Staff Report
City of Richmond, Virginia

Commission of Architectural Review

4. COA-105887-2022	Final Review Meeting Date: 2/22/2022
Applicant/Petitioner	Louise Lockett-Gordon
Project Description	Replace existing concrete roofing tiles with asphalt shingles and enclose a rear porch.
Project Location	
Address: 3833 Hermitage	
Historic District: Hermitage Road	
High-Level Details: <ul style="list-style-type: none"> The applicant request approval to rehabilitate the exterior of a ca. 1923 Craftsman style residence The applicant proposes to remove the original concrete tile and replace with asphalt shingles, and to enclose a rear, inset porch. Staff notes that this work has already been completed. Original windows are proposed to be repaired and replaced as necessary The applicant proposes to paint the body of the residence dark blue. In-kind replacement of original wooden soffits and fascia boards as well as general maintenance 	
Staff Recommendation	Partial Approval
Staff Contact	Alex Dandridge, alex.dandridge@rva.gov , (804) 646-6569

Figure 6. Tile, French Profile example.

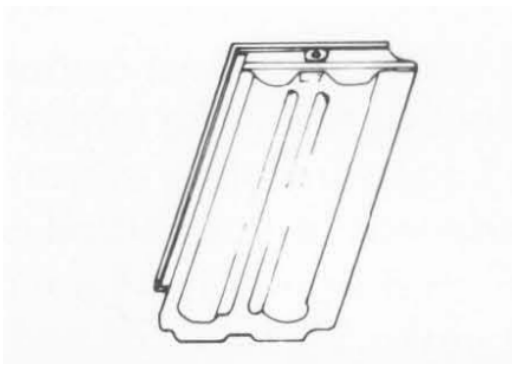
Previous Reviews	Staff was able to contact the owner and have work stop on the exterior of the property before having to issue a formal notice of violation.
Conditions for Approval	<ul style="list-style-type: none"> Staff recommends denial of the use of asphalt shingles on the visible portions of the roof. Staff recommends that a roofing material that more closely resembles the original in style and form be installed on the visible portions of the roof, such as a clay or concrete tile with a French profile. (See Figure 7). Staff recommends approval of the applicants color selections for the body and trim, “blue coal” and “varsity white”. Staff recommends approval of the rear porch enclosure with the condition that the enclosure be clad in a material different from the main building, such as horizontal siding, and that exterior trim pieces be used to indicate the historic location
